03-Sut-99-26.6/37.4
03-1A4614
Highway Widening (Tudor Bypass)

CONTRACT CHANGE ORDER

CCO No. 38	Suppl. No. 0	Contract No. 03-1A4614	Road Sut-99,113-26.6/37.4,25.7/R26.6 (KP)	Federal Number(s) No Fed-Aid
---------------	-----------------	---------------------------	--	---------------------------------

03-1A4614
CCO #38
Contract Change Order
SHEET 4 OF 5

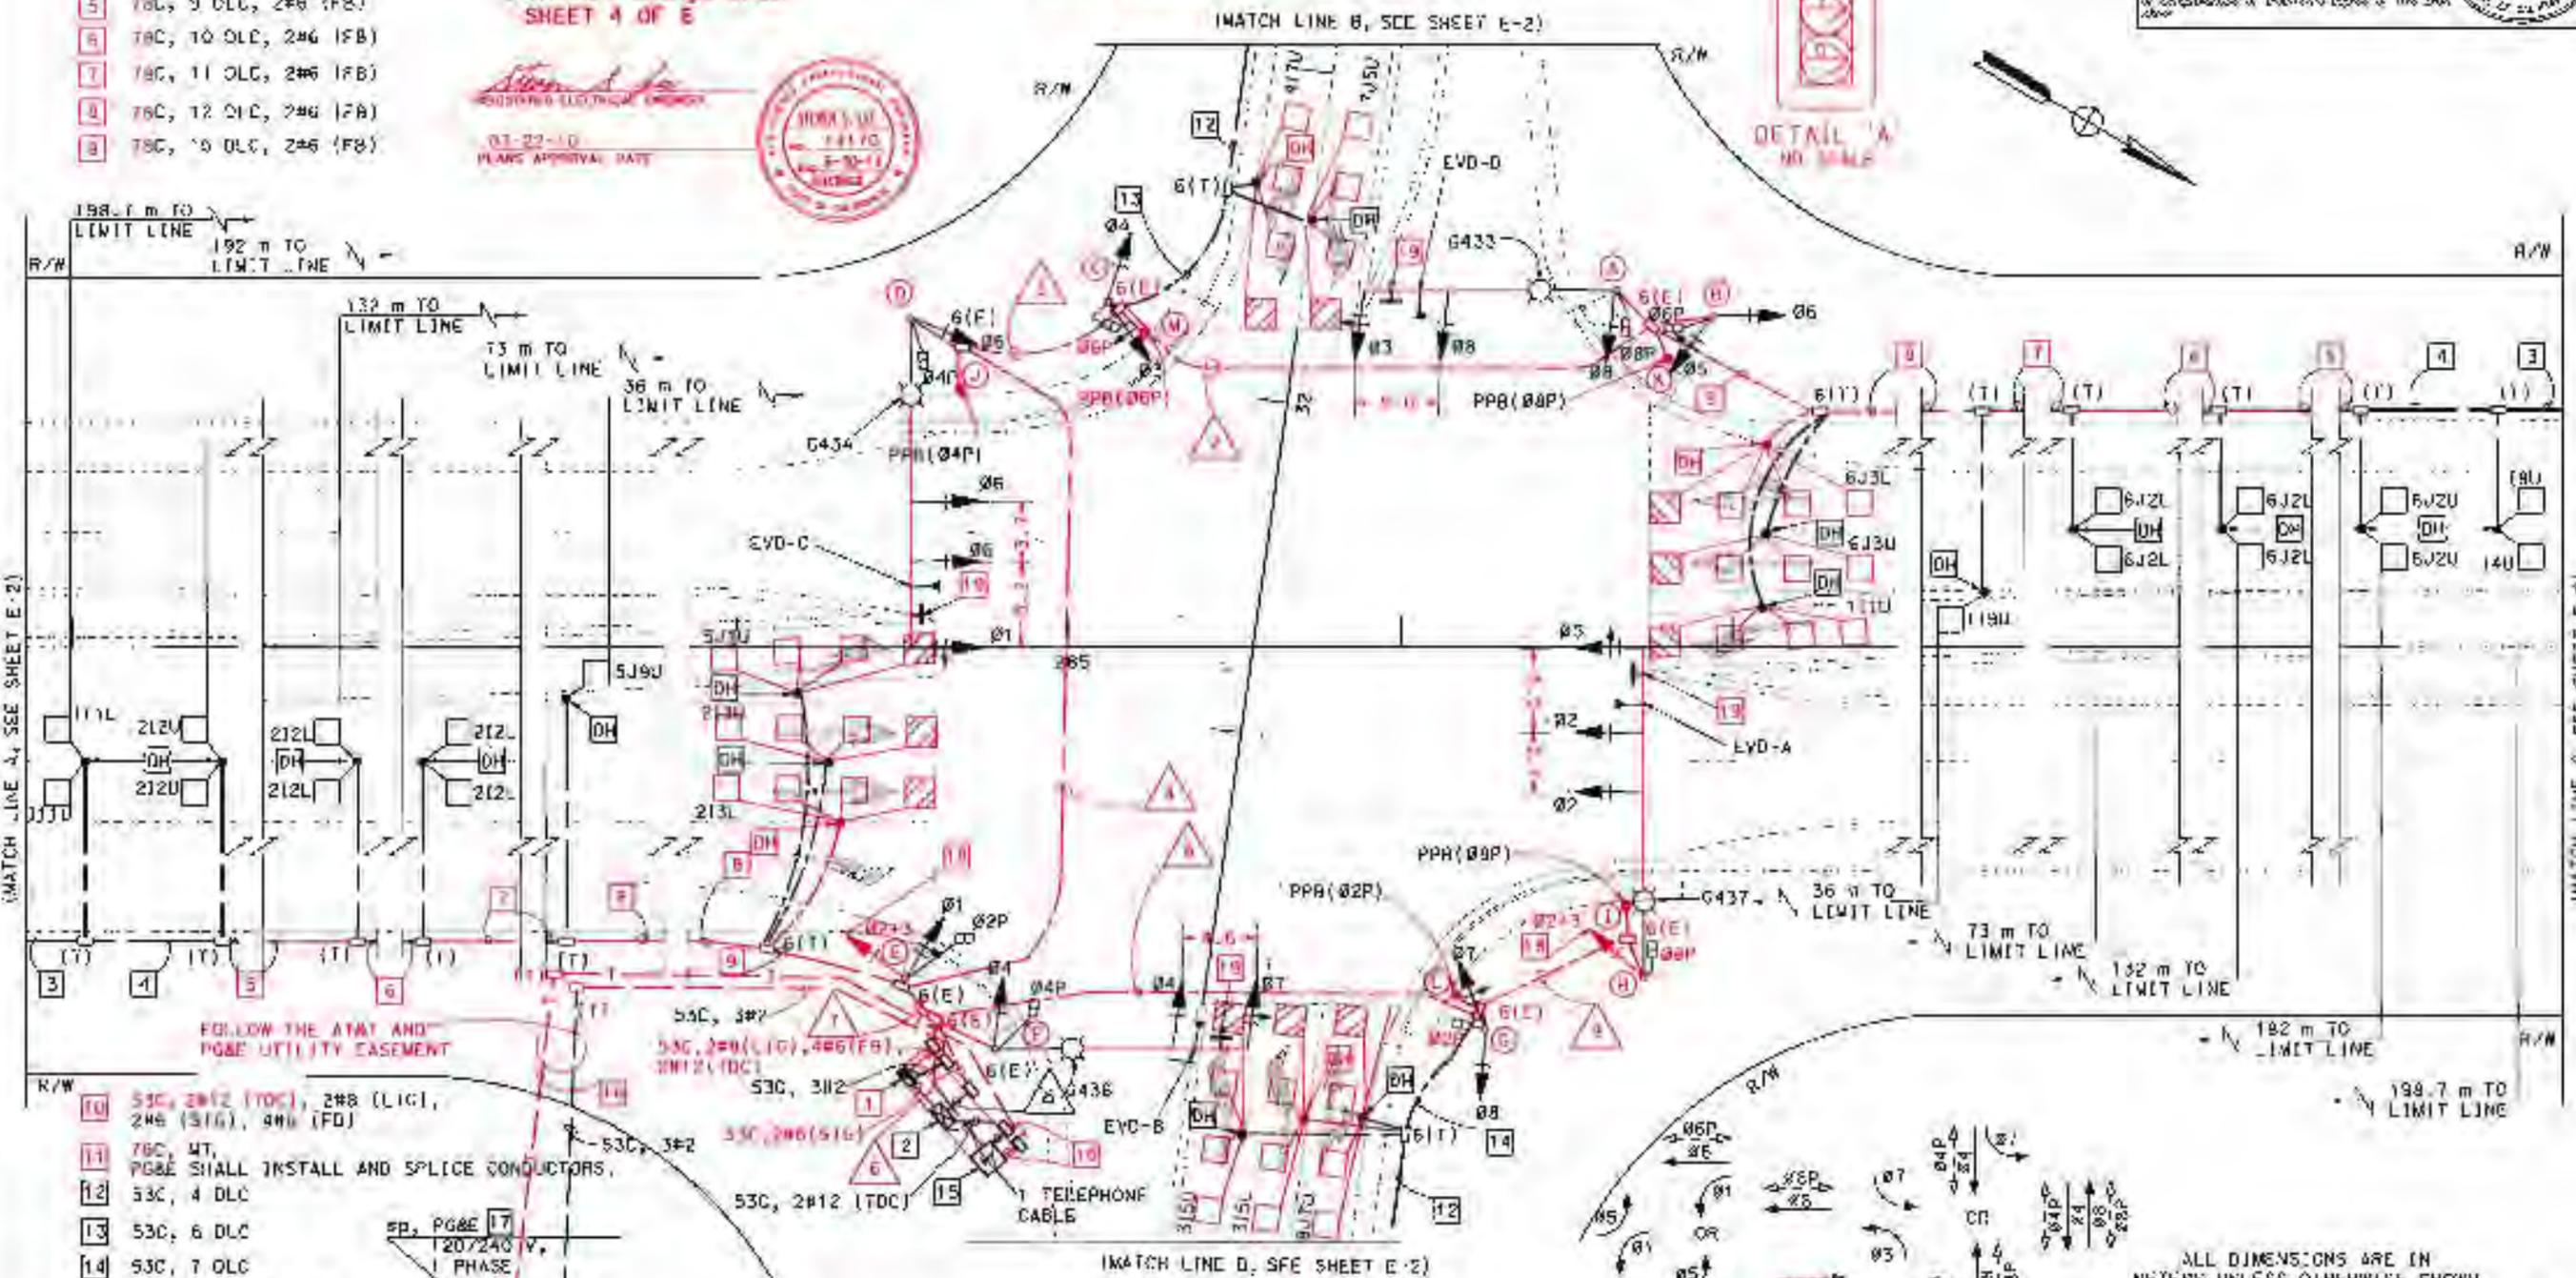
- 1) Replace the contract plan sheets No. 294 (E-1) and No. 296 (E-3) with sheets 4 and 5 of this contract change order.
- 2) Perform the electrical work as indicated on sheets 4 and 5 of this contract change order.
- 3) Add attached Revised Standard Plan sheet RSP ES-7H.
- 4) Perform the following work:

- 1 TYPE III AF SERVICE EQUIPMENT ENCLOSURE CTID No. 0318099R017730, FOR SERVICE WIRING DIAGRAM SEE SHEET E 2A.
- 2 STATE-FURNISHED TYPE 332 CABINET AND MODEL 2070 CONTROL FR ASSEMBLY.
- 3 53C, 5 OLC, 2#6 (FB)
- 4 53C, 8 OLC, 2#6 (FB)
- 5 78C, 9 OLC, 2#6 (FB)
- 6 78C, 10 OLC, 2#6 (FB)
- 7 78C, 11 OLC, 2#6 (FB)
- 8 78C, 12 OLC, 2#6 (FB)
- 9 78C, 13 OLC, 2#6 (FB)

- 10 53C, 2#12 (TDC), 2#8 (LIG), 2#6 (SIG), 4#6 (FD)
- 11 78C, 4T, PG&E SHALL INSTALL AND SPLICE CONDUCTORS.
- 12 53C, 4 OLC
- 13 53C, 6 OLC
- 14 53C, 7 OLC
- 15 INSTALL TYPE B TDC
- 16 53C, 4T, TELEPHONE CABLE SHALL BE INSTALLED BY AT&I
- 17 INSTALL TYPE PG&E RISER
- 18 INSTALL 3-SECTION VERTICAL STACKED SIGNAL HEAD, SEE DETAIL 'A' THIS SHEET.
- 19 INSTALL SIGN ON SIGNAL MAST ARM, SEE PAVEMENT DELINEATION AND SIGN PLANS.
